SERVICE LETTER

No. SL-AG-128

AIRCRAFT LANDING GEAR

This Service Letter provides instructions for adjusting the height of Retainer Cap 95205 when installing Main Landing Gear Assembly 95211.

Figure 1
Main Landing Gear Assembly & Retainer Cap

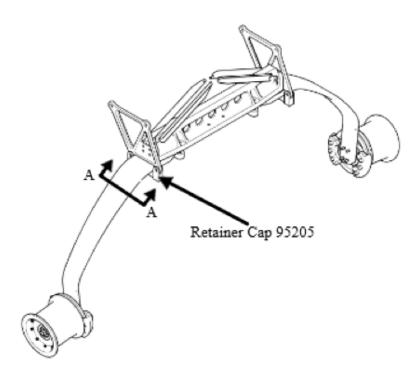
- 1) Re-install Main Landing Gear Assembly 95211. Refer to Figure 128-1.
- 2) Determine amount to be milled from Retainer Cap 95205 by measuring the distance from center of bolt hole to lower surface of Spacer 95207. Add 0.020 inches to this value for clearance. Refer to Figure 128-3.

Figure 2 Milling Surface of Retainer Cap 95205-5

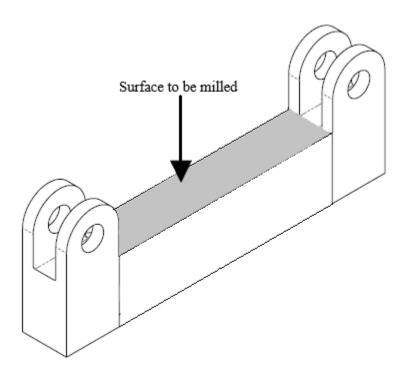
- 3) Use the metal milling machine to machine determined amount from surface of Retainer Cap 95205. Ensure machine clamps do not damage other surfaces of Retainer Cap 95205. Refer to Figure 128-2.

Figure 3
Milling Dimension of Retainer Cap 95205
View A-A REF Figure 1

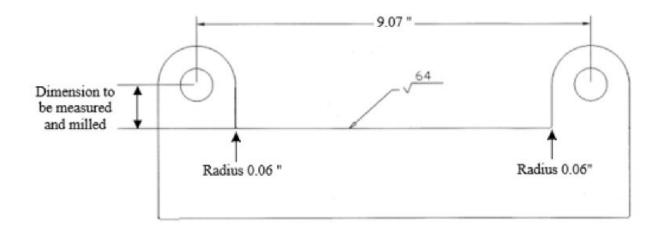
- 5) Surface finish of machined area shall be at least 64 RMS. Refer to Figures 128-3 &128-4.
- 6) Verify proper fit of Retainer Cap 95205.
- 7) Restore corrosion protection by corrosion converting milled surface per MIL-DTL-81706A. The following products can be used:

Figure 4
Thickness of Retainer Cap 95205
View A-A REF Figure 1

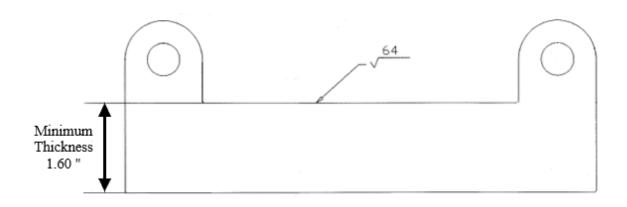
- 4) Minimum thickness of Retainer Cap 95205 should be 1.60 inches. Measure and record thickness of Retainer Cap 95205 on pages 5 and 6. Refer to Figure 128-4. Contact Thrush Aircraft if minimum thickness cannot be maintained.
